TECHNICAL REVIEW OF RISK DUE TO  
EXPANSION OF THE MORRIS OPERATION  
SPENT NUCLEAR FUEL STORAGE

ILLINOIS ATTORNEY GENERAL

MHB TECHNICAL ASSOCIATES  
366 CALIFORNIA AVENUE  
PALO ALTO, CALIFORNIA 94306

FEBRUARY 1979

FIGURE 4-2 -B

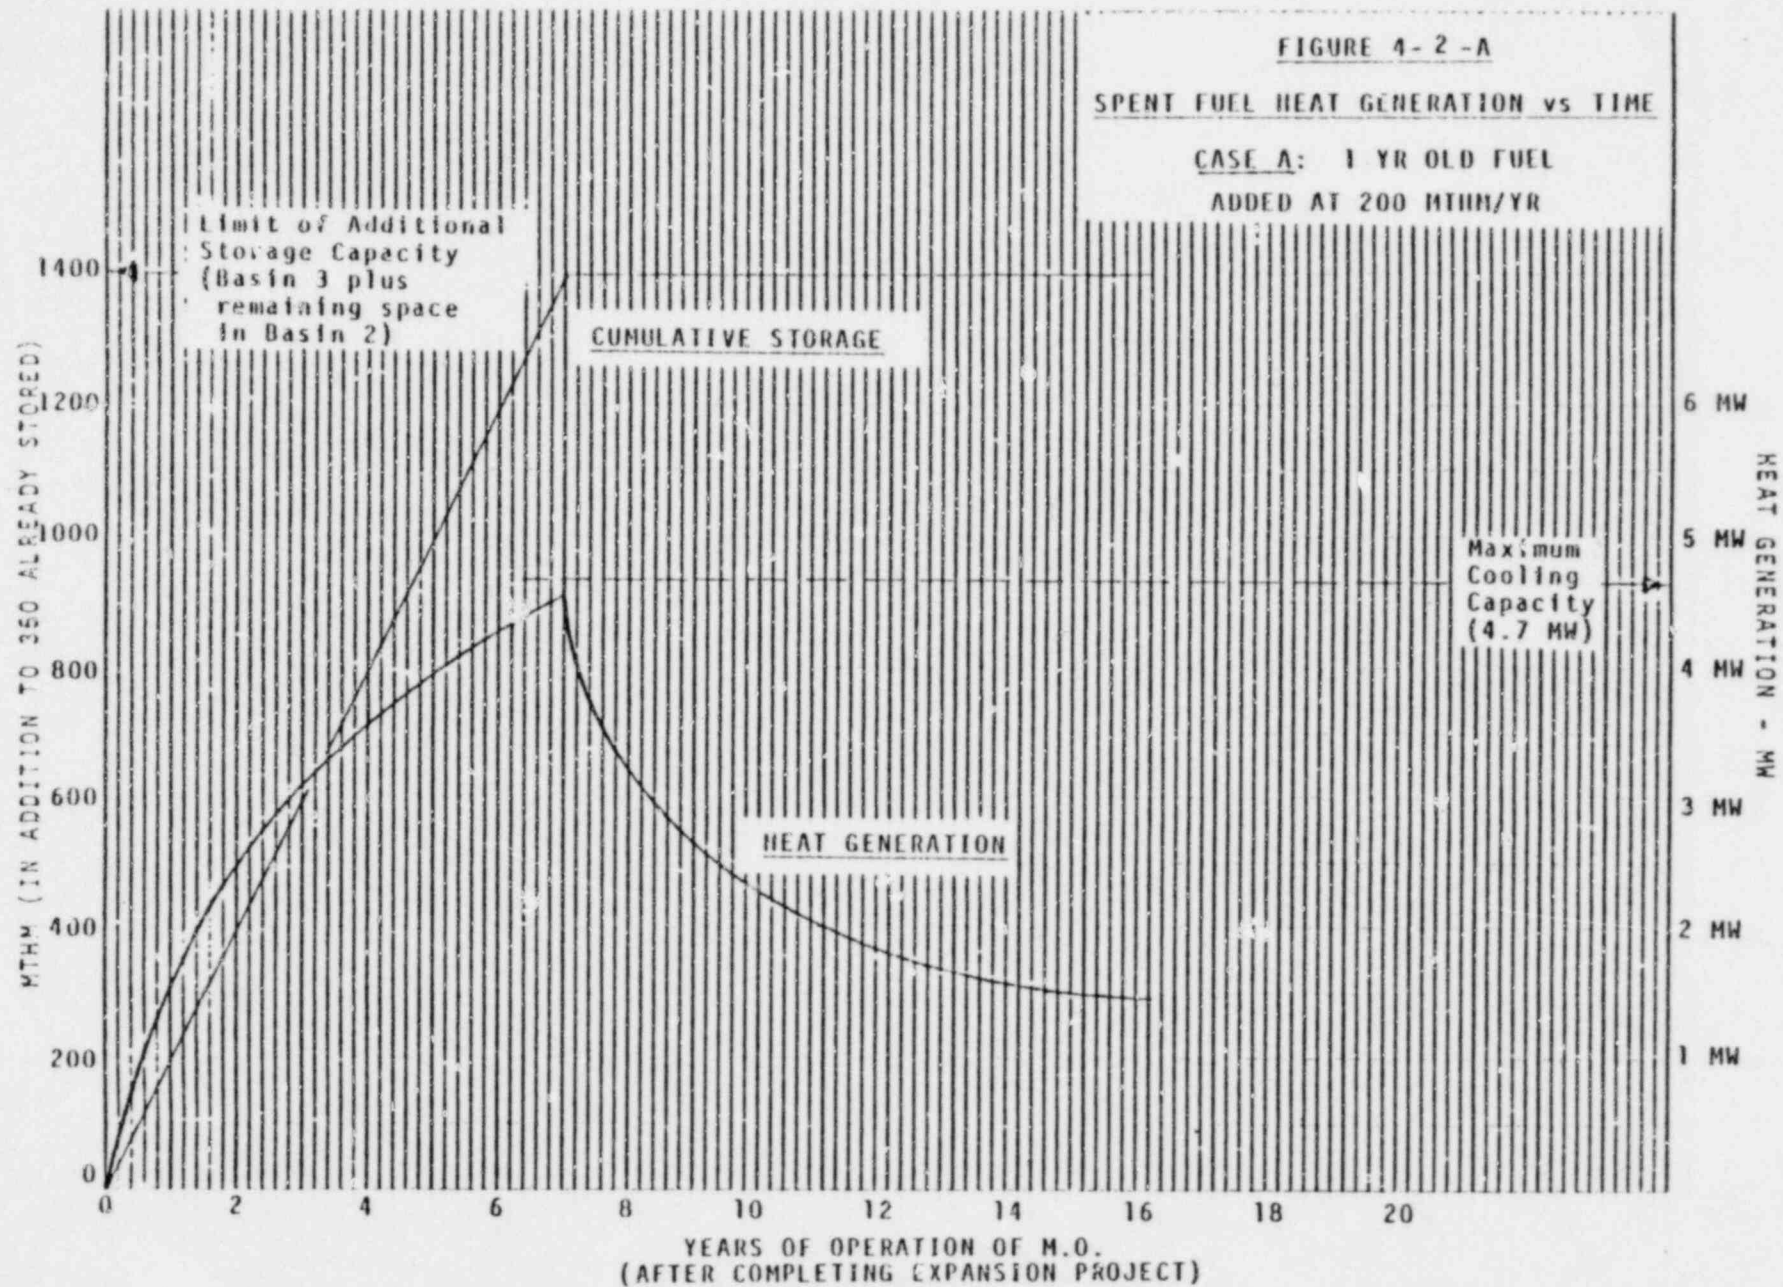
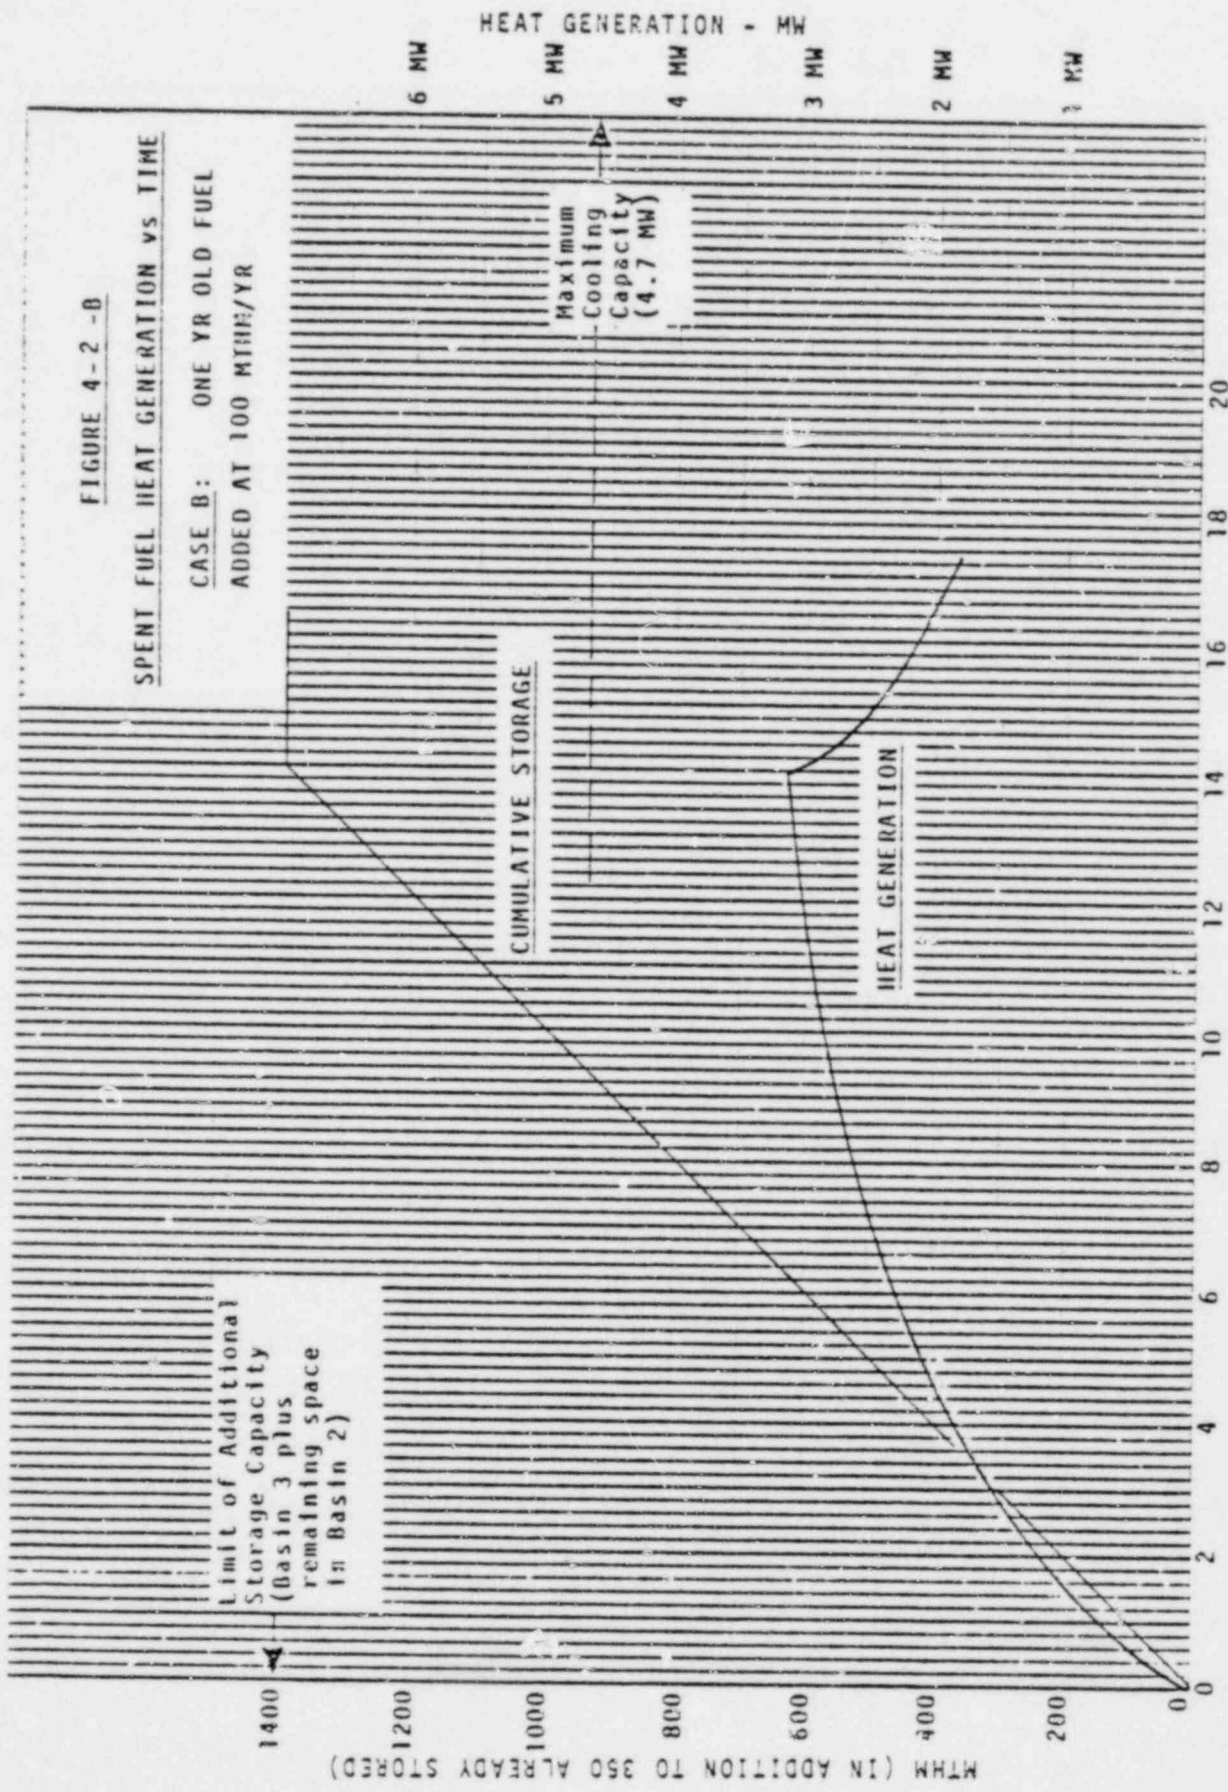
Another critical variable is the rate at which spent fuel is received at the MO. Figures 4-2 A and 4-2 B analyze two cases which show the impact of rate of arrival of spent fuel. Assuming that one year old fuel is received at 200 MTHM per year, the pools will be filled in seven years, and the cooling system is marginally able to accommodate the resulting inventory of spent fuel and its generated heat.

has been less than one year out of the reactor and/or received at a rate greater than 200 MTHM/year,<sup>(25)</sup> the cooling capacity appears to be marginal or inadequate. The CSAR does not analyze the maximum rate of receipt of spent fuel with the upper limit conditions of exposure, specific power and recency of discharge.
